ADDENDUM NO. 1

Notice to All Persons and Firms Proposing
to Submit a Bid or Furnish Materials for
Hanley Road (B) Resurfacing
St. Louis County Project No. AR-1484
EWGCG T.I.P. No. 6346-16
Federal Project No. STP-5613(604)

The construction contract for this project has been revised as follows:

DESIGNED: J.L.M.
DRAWN: J.L.M.
CHECKED: E.W.
SHEET SEQUENCE:
21 OF 28

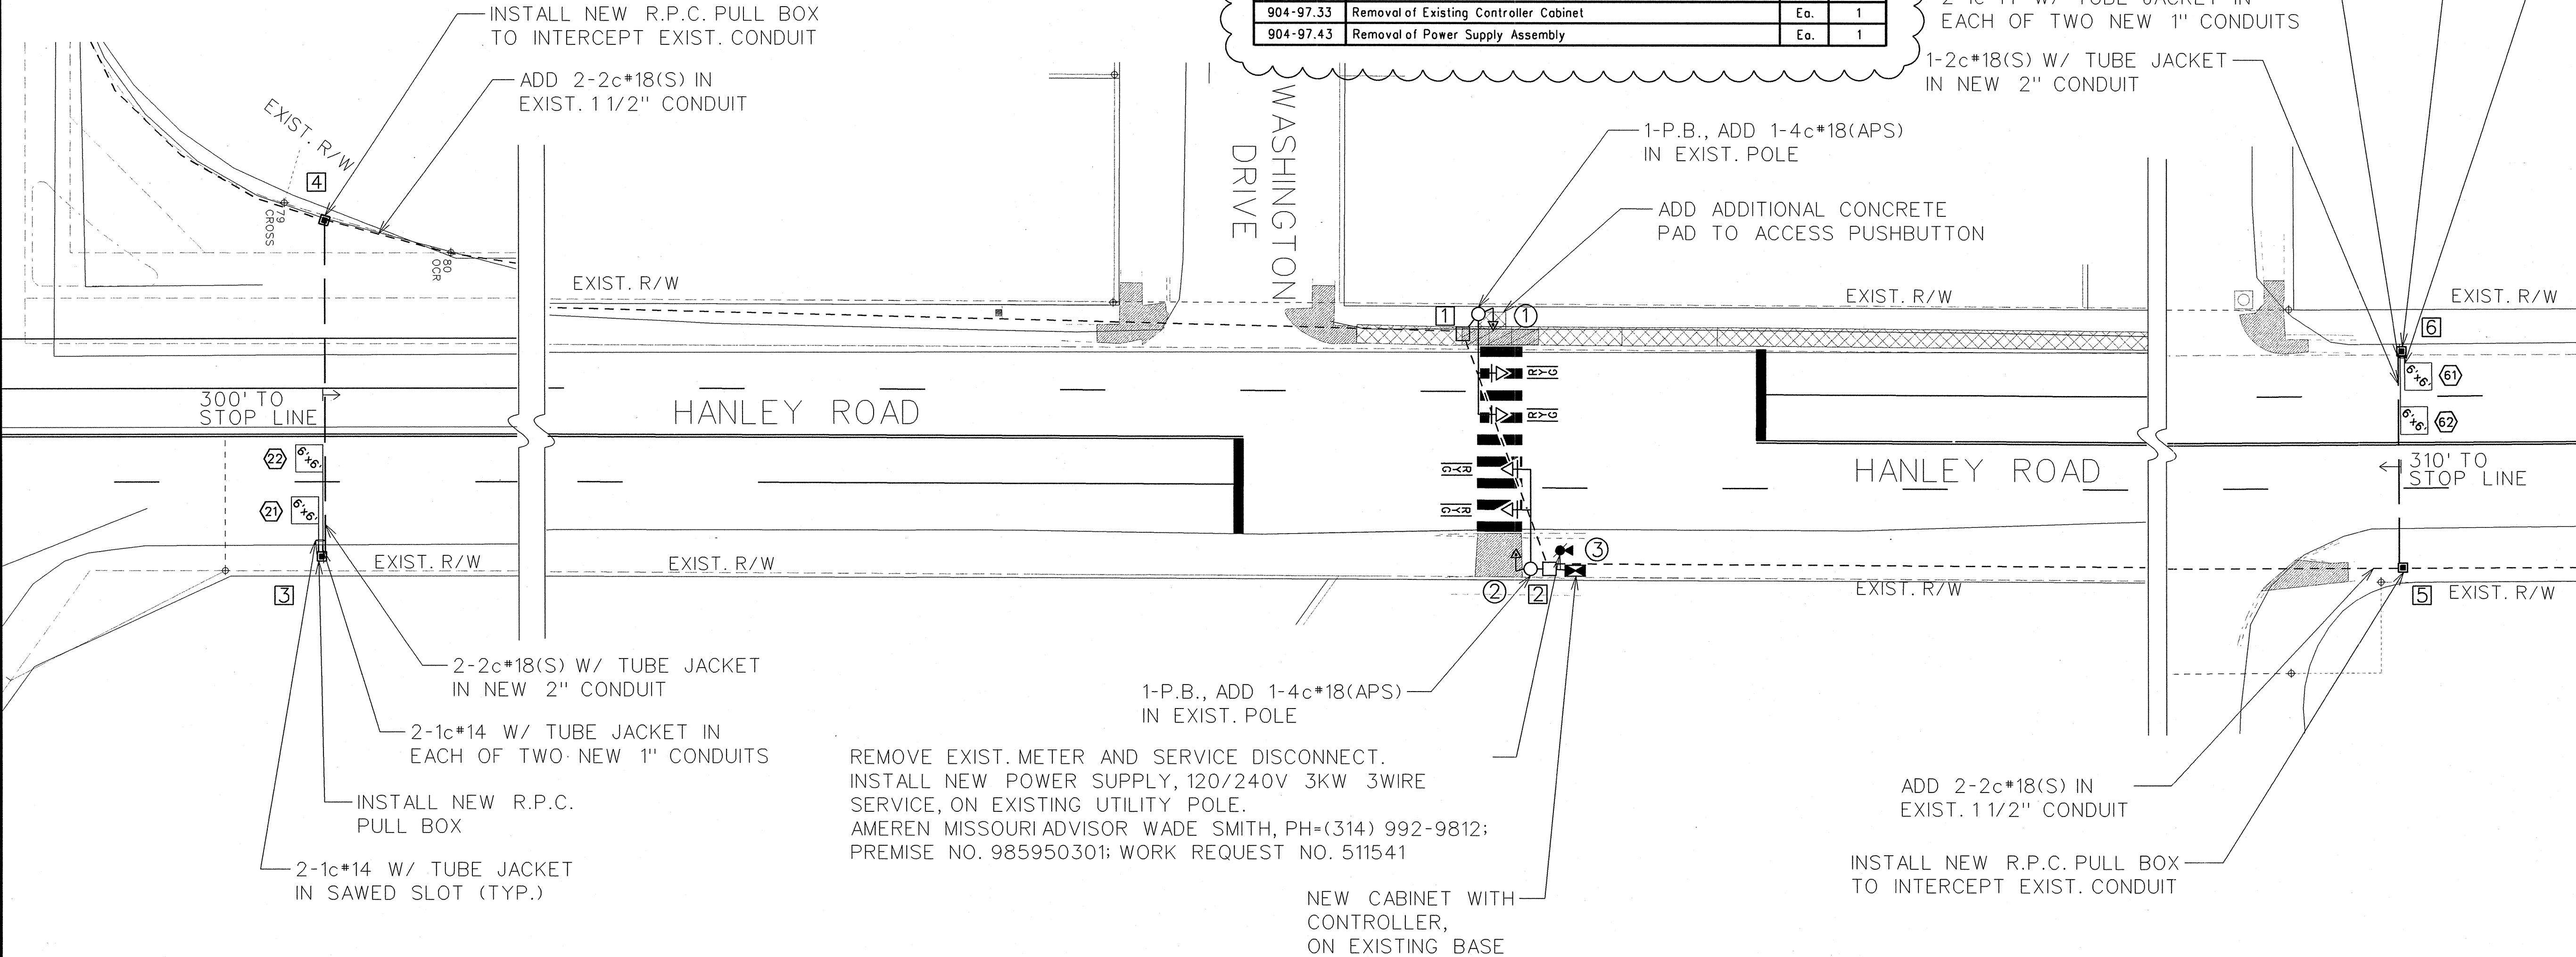
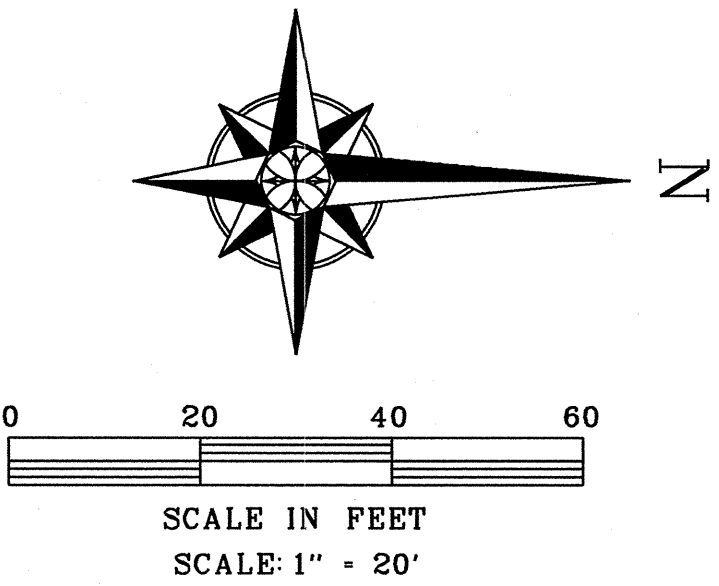
Replace Plan Sheet 21 of 28 and 23 of 28 with the attached revised sheets.
